VILLAGE OF GERMANTOWN
N112 W17001 MEQUON ROAD, GERMANTOWN, WI 53022

MEETING: **PLAN COMMISSION**
DATE AND TIME: **MONDAY, JUNE 8, 2020 6:30 p.m.**
LOCATION: **VIRTUAL WEBEX MEETING:**

AGENDA

PLAN COMMISSION MINUTES
May 11, 2020

Figure 1.

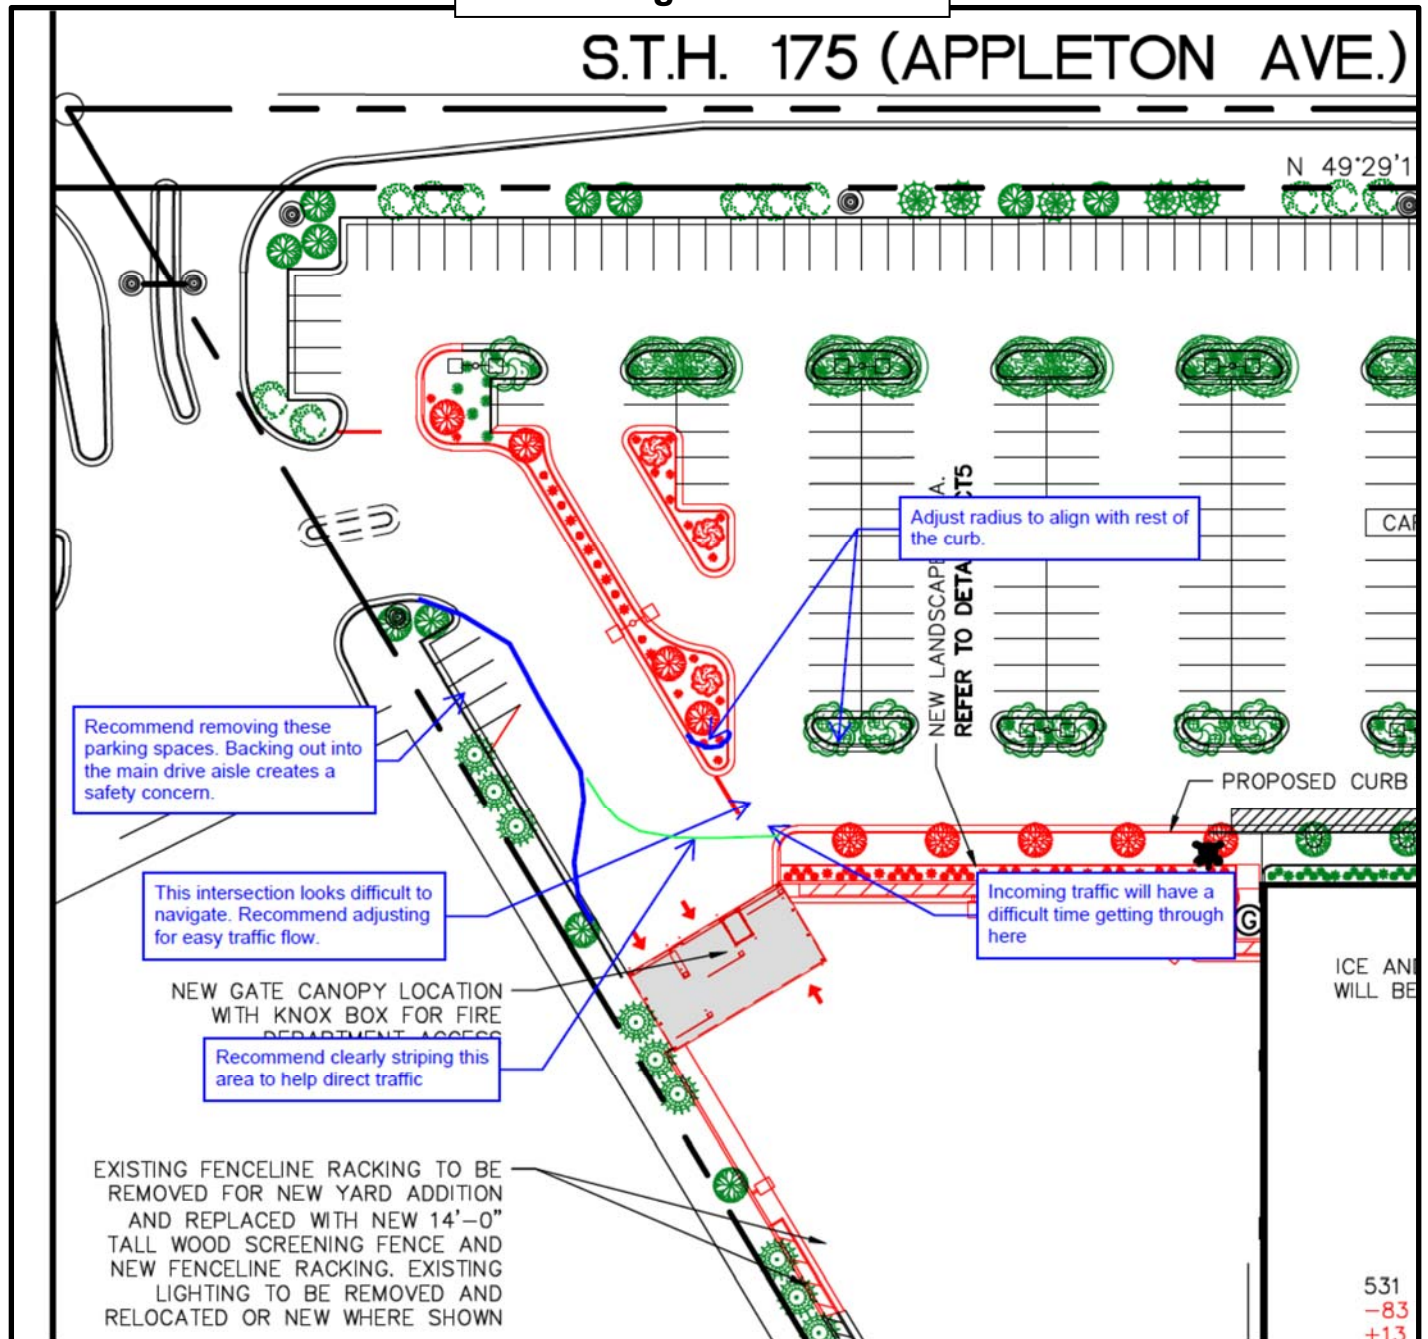
Comments from the Village Engineer regarding the proposed driveway modifications proposed by Menards to address the concerns raised by the PC regarding the shared driveway w/ Steins Garden Center are shown on Figure 1:

Germantown, Wisconsin
Menards Site Plan
May 21, 2020
Scale: 1" = 50'-0"

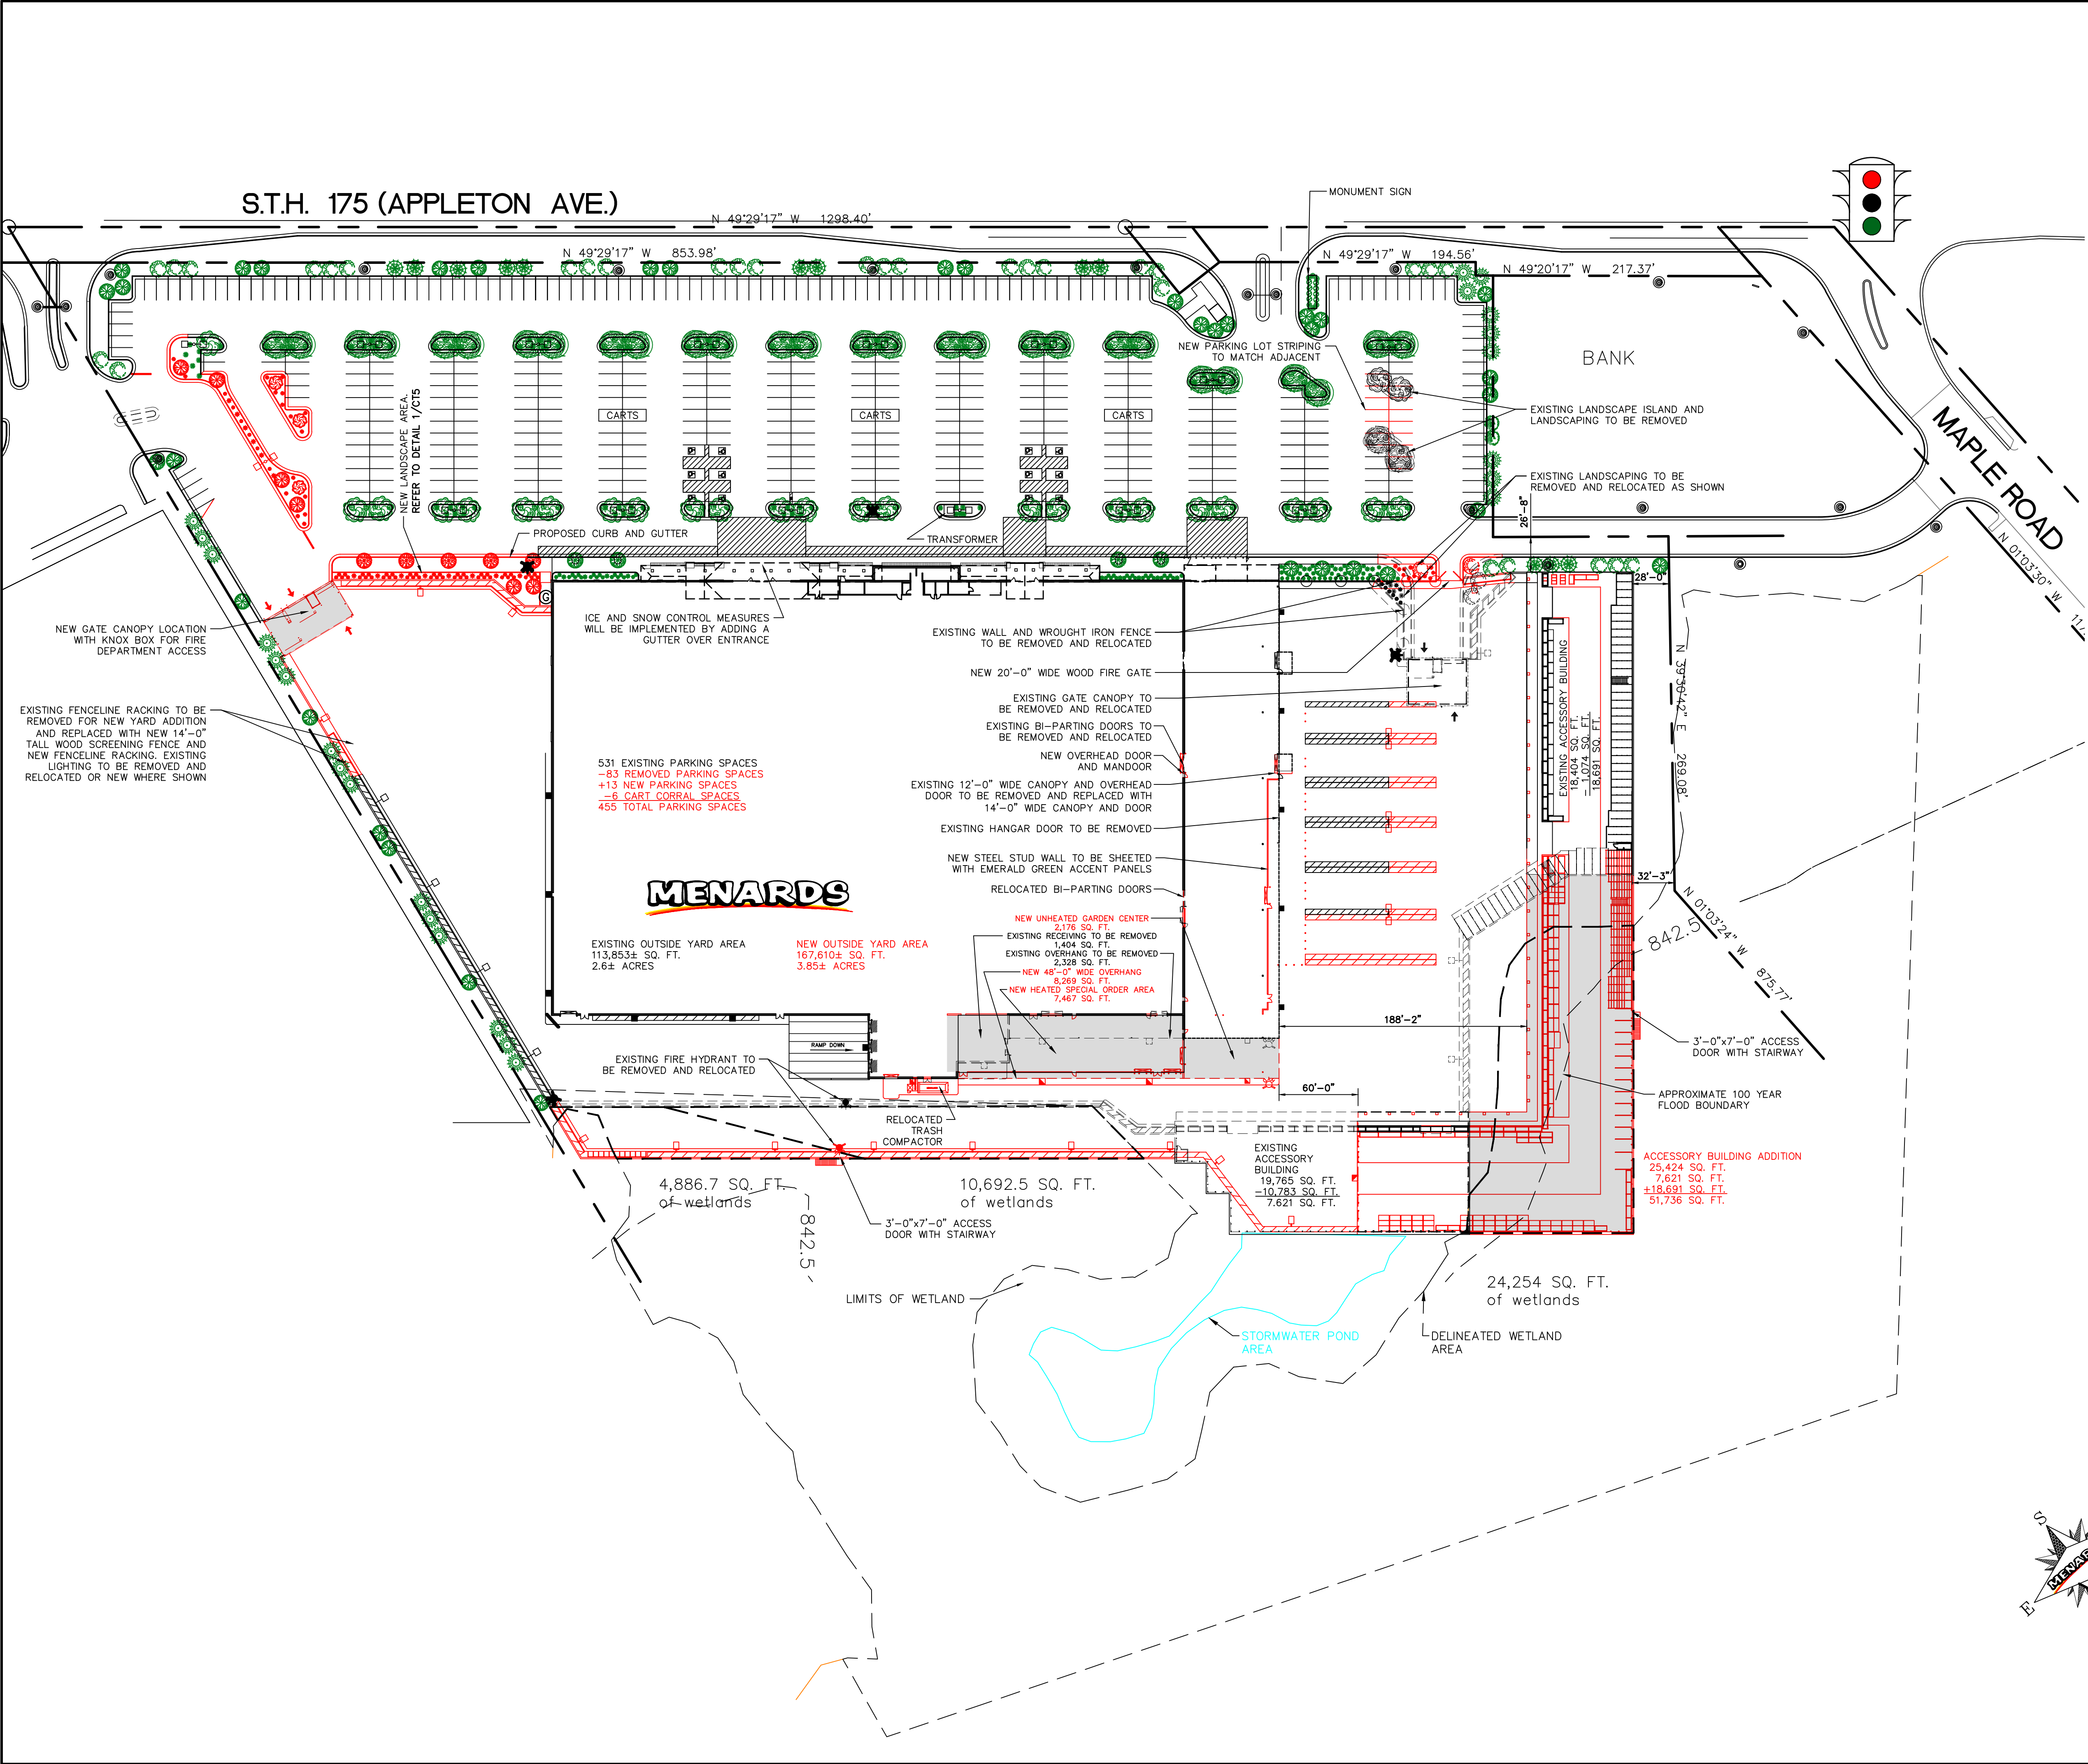
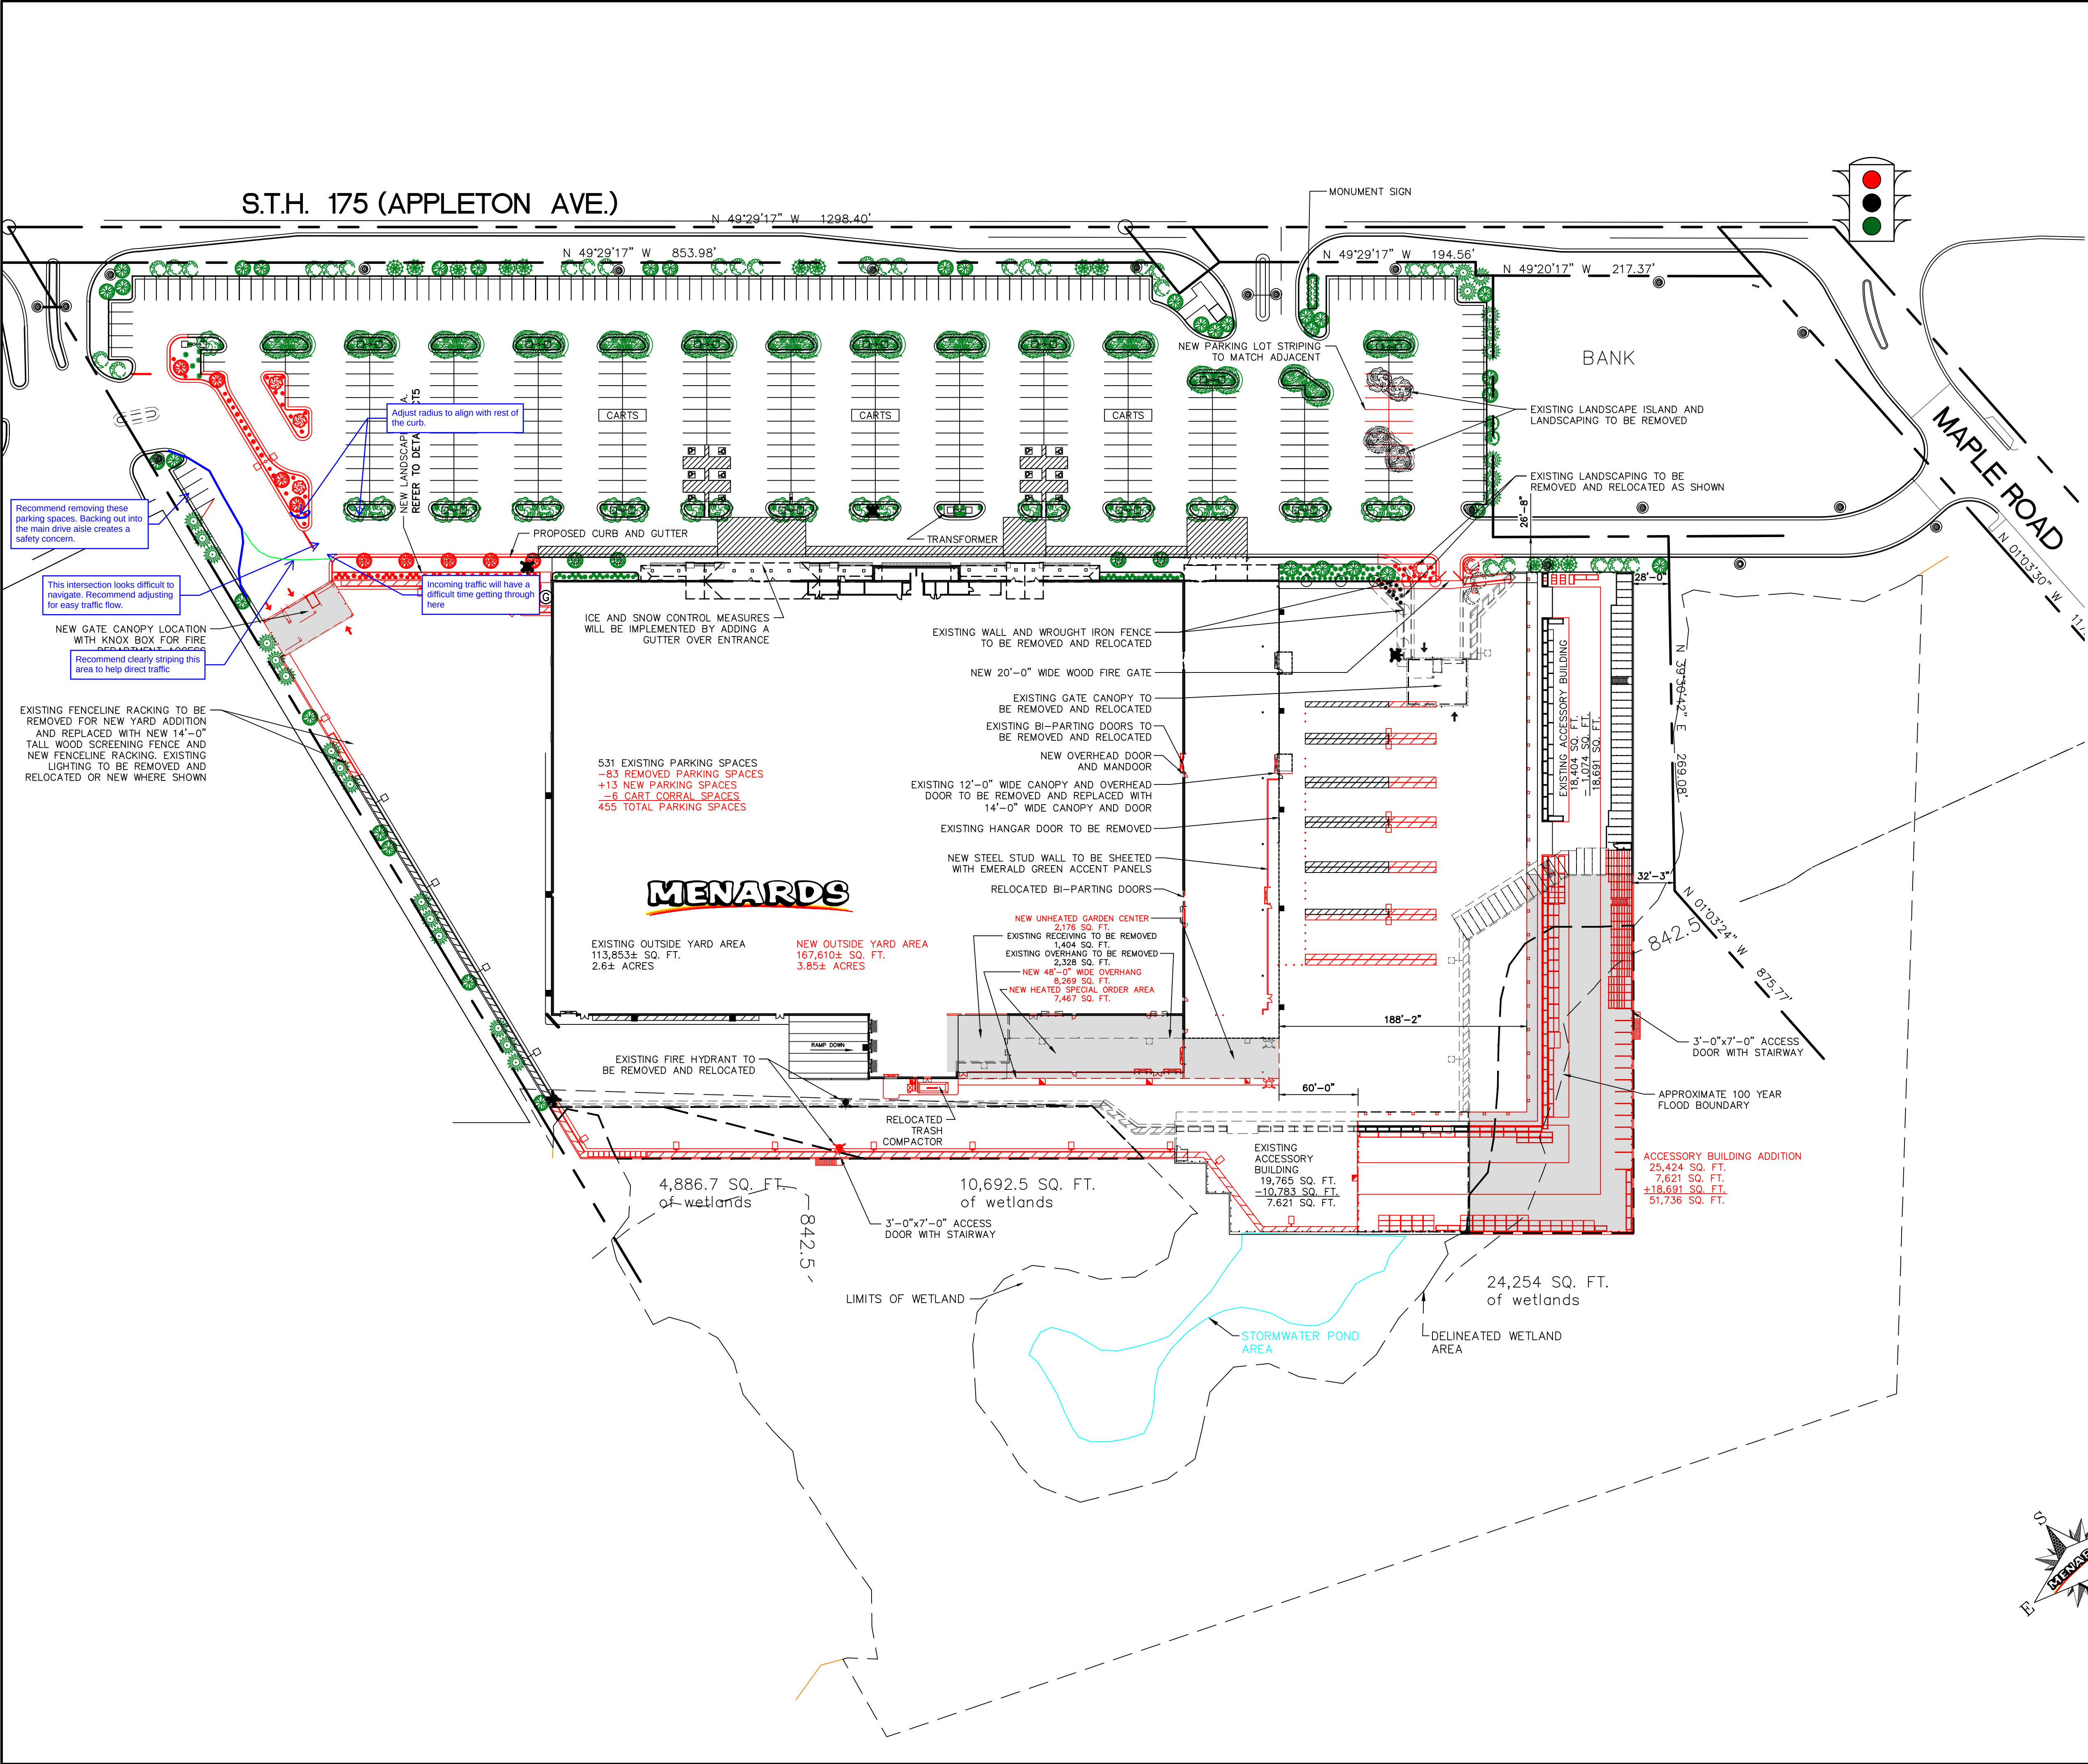
ENGINEER COMMENTS
